Access Compliance Report Public Rights-of-Way (Curb Ramps)

Intersection ID: 19953 Main Street: ARCHDALE_DR Cross Street: OLD_PINEVILLE_RD Location: SE

ADA ID: 673B3E625862 Ramp Type: BlendTrans2 Initial Pass/Fail: Pass Overall Compliance: No Severity Score: 0.25

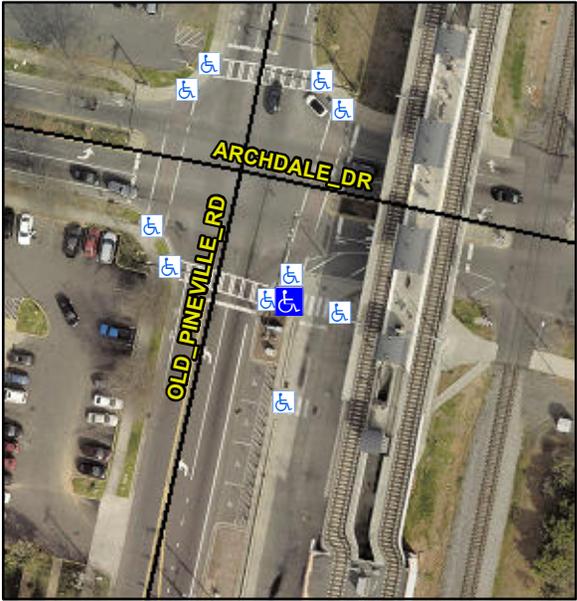
Possible Solutions:
Remove & Replace Curb Ramp With Two New Directional Ramps or Equivalent.

PROW/ADA:
Not Found, R304.5.3, R304.2.3

Compliance	Description	Data	Compliance	Description	Data
N/A	Ramp Length (in)	64.0	Yes	BlendTrans Slope (%)	1.2
Yes	Ramp Width (in)	96.0	No	BlendTrans XSlope (%)	3.8
N/A	Flare Type LT	Sloped	N/A	Flare Type RT	Sloped
N/A	Flare Slope LT (%)	N/A	No	Flare Slope RT (%)	N/A
N/A	Flare Traversable LT?	No	N/A	Flare Traversable RT?	Yes
N/A	Landing Length (in)	N/A	Yes	DWS Provided?	Yes
N/A	Landing Width (in)	N/A	Yes	DWS Contrast?	Yes
N/A	Landing Slope (%)	N/A	Yes	DWS Length (in)	24.0
N/A	Landing X Slope (%)	N/A	Yes	DWS Full Width?	Yes
N/A	Landing Curb? (Y/N)	No	Yes	DWS Offset (in)	0.0
N/A	Shared Landing?	No			
Yes	Gutter Ponding?	No	Yes	Gutter Slope (%)	1.4
Yes	Gutter Lip Ht (in)	0.0	Yes	Gutter X Slope (%)	0.1
N/A	Painted X Walk1?	Yes	N/A	Painted X Walk2?	N/A
	X Walk 1 Direction	To E		X Walk 2 Direction	N/A
	X Walk 1 Width (in)	120.0		X Walk 2 Width (in)	N/A
	X Walk 1 Slope (%)	1.4		X Walk 2 Slope (%)	N/A
	X Walk 1 X Slope (%)	0.5		X Walk 2 X Slope (%)	N/A

Yes	Ramp inside XWalk1?	Yes	N/A	Ramp inside XWalk2?	N/A
	Road Slope (%)	0.5		Clear Space?	Yes
	Road X Slope (%)	1.4	N/A	Clear Space to XWalk (in)	N/A
Yes	Any Obstructions?	No	Yes	Storm Grate/Utility Hazard?	No
	Obstruction Type			Storm Grate/Utility Type	
			N/A		N/A
			Yes	Surface Condition? (G/P)	Good
			No	Curb Slope (%)	13.7
